City of Detroit  
Inter-Departmental Communication

**RE:** Petition No. 1446  
Requested Encroachment Into Griswold At 1214 Griswold With A Bike Rack

**NOTICE OF PROPOSED CHANGE IN PROPERTY**

REQUEST ENCROACHMENT  
 INTO GRISWOLD  
 AT 1214 GRISWOLD  
 (With Bike Rack)

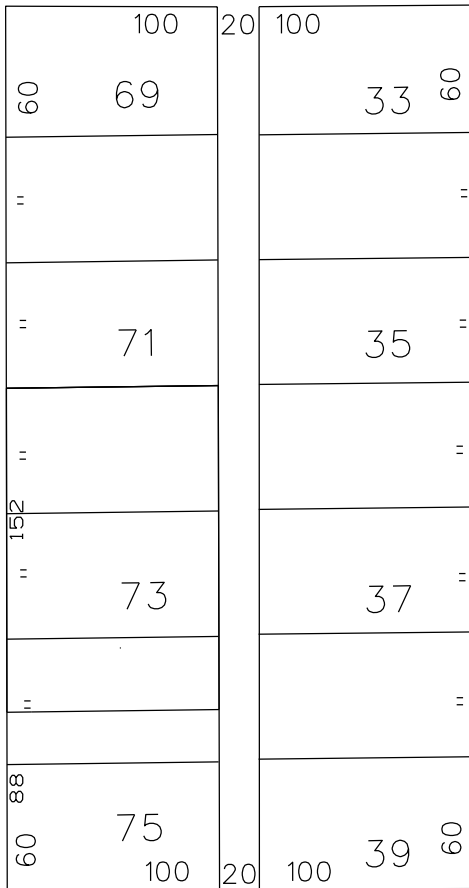
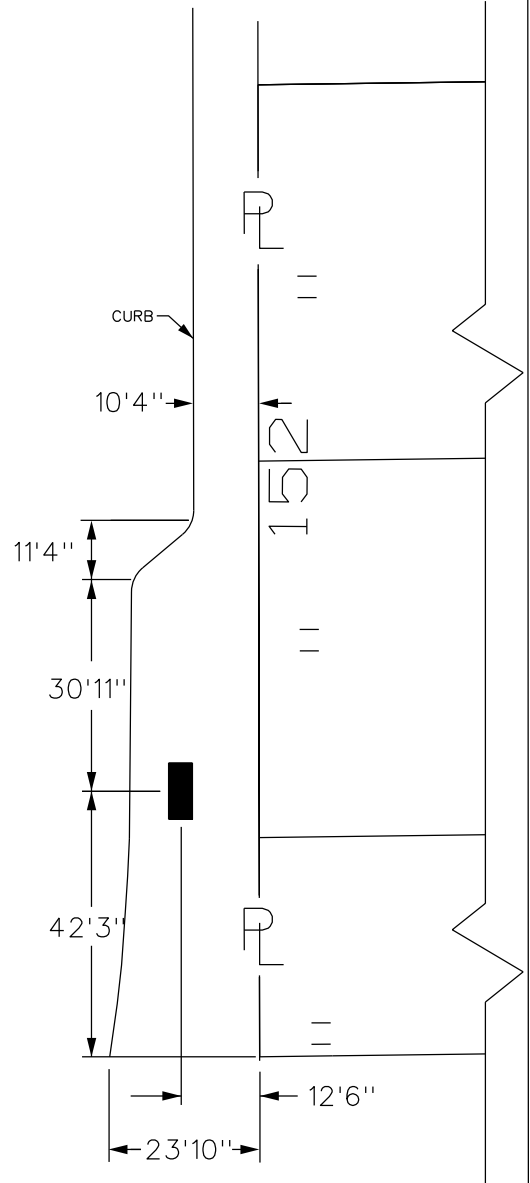
- DWSD has no objection to the requested encroachment provided that the attached Provisions for Encroachment are strictly followed.

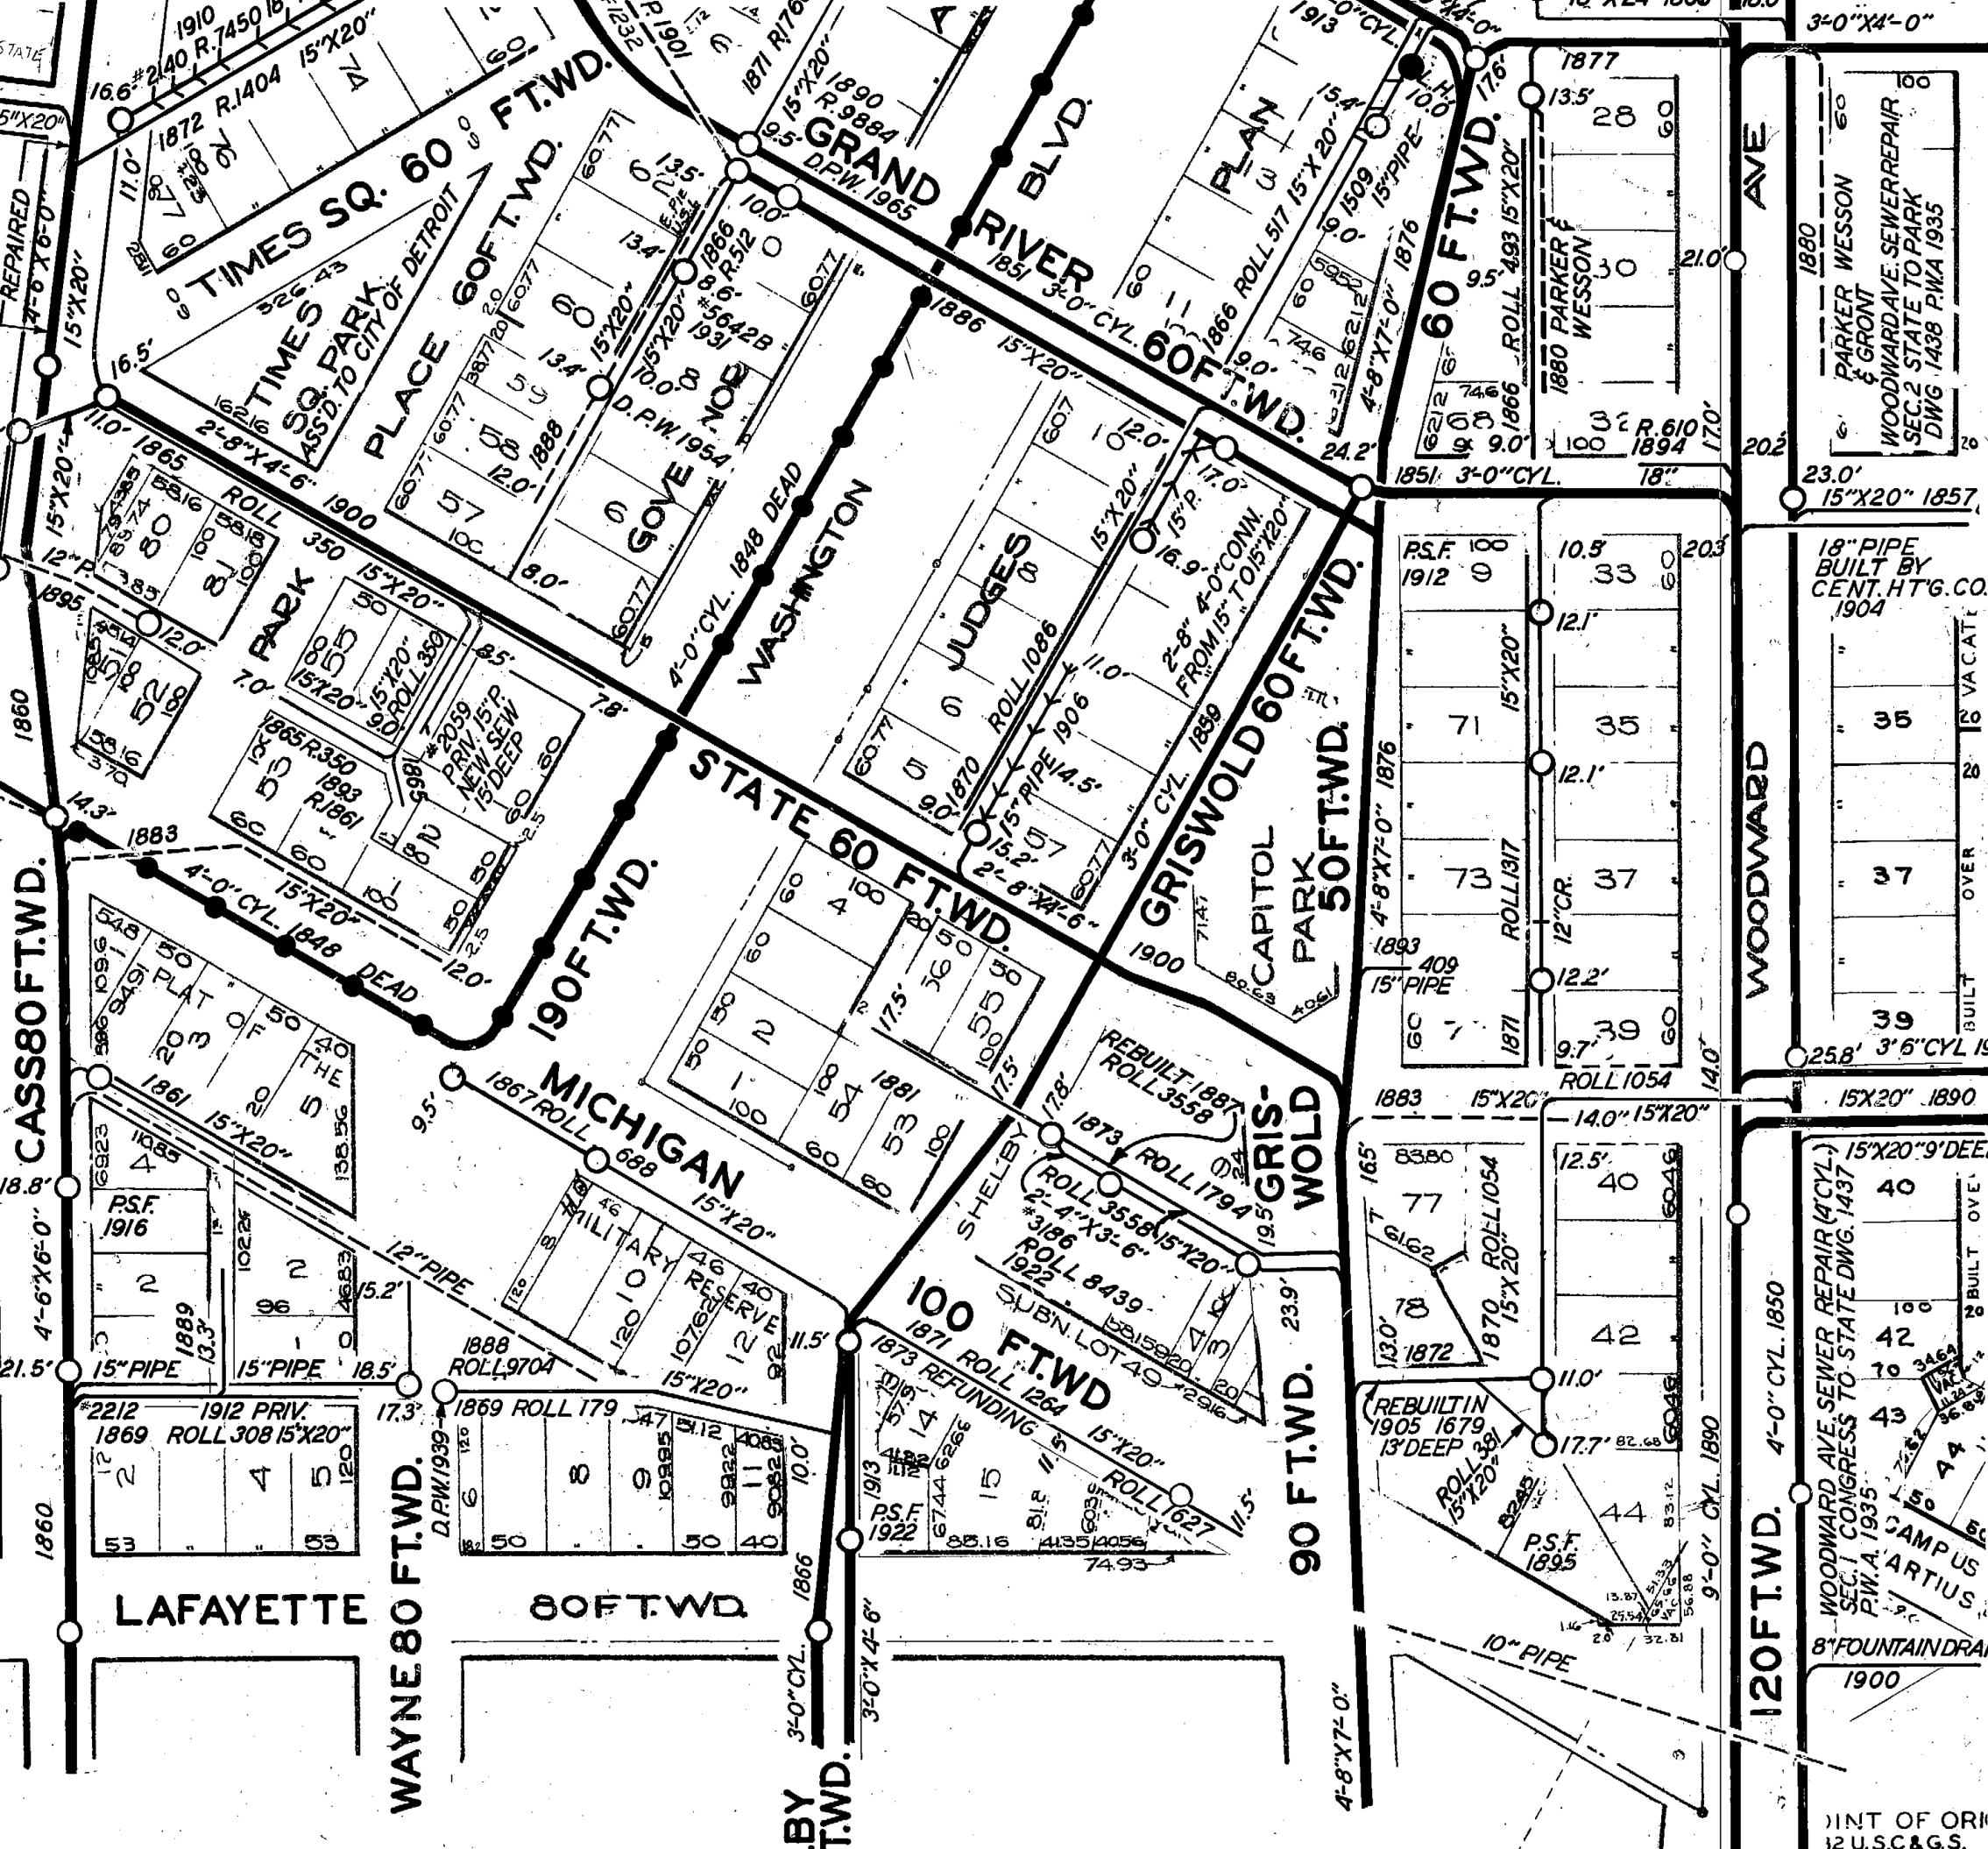
- Our records indicate that there are water mains and sewers which are located in the vicinity of the proposed project limits.
- It is DWSD's requirement that any proposed utility crossing DWSD water mains or sewers perpendicularly must maintain a minimum of 18 inches vertical clearance. Also any proposed utility running adjacent to DWSD water mains and sewers must maintain a minimum of 5 feet lateral clearance including any conduit and/or manholes walls. No utility is allowed to run along the top of the water main or sewer.

- There are possibilities of several water and sewer service lines crossing in the vicinity of proposed work, field verify their location and depth to maintain our required clearance.

- Detroit Water and Sewerage Department (DWSD) prohibits the use of heavy construction equipment (bulldozers, backhoes, extremely large rollers, etc.) and or storage of building material directly over or near our mains or sewers. DWSD also prohibits the use of cranes and balls or hydraulic rams for pavement removal where the DWSD facilities are involved. If the water main or sewer facilities are broken or damaged as a result of any action on the part of the contractor, then the contractor shall be liable for all costs incidental to the repair of such broken or damaged water main/sewer facilities and appurtenances. The contractor shall waive all claims for damages under such circumstances.

- For any proposed work that involves DWSD utilities (water mains and/or sewers), an approval and a permit is required from DWSD before the commencement of work.
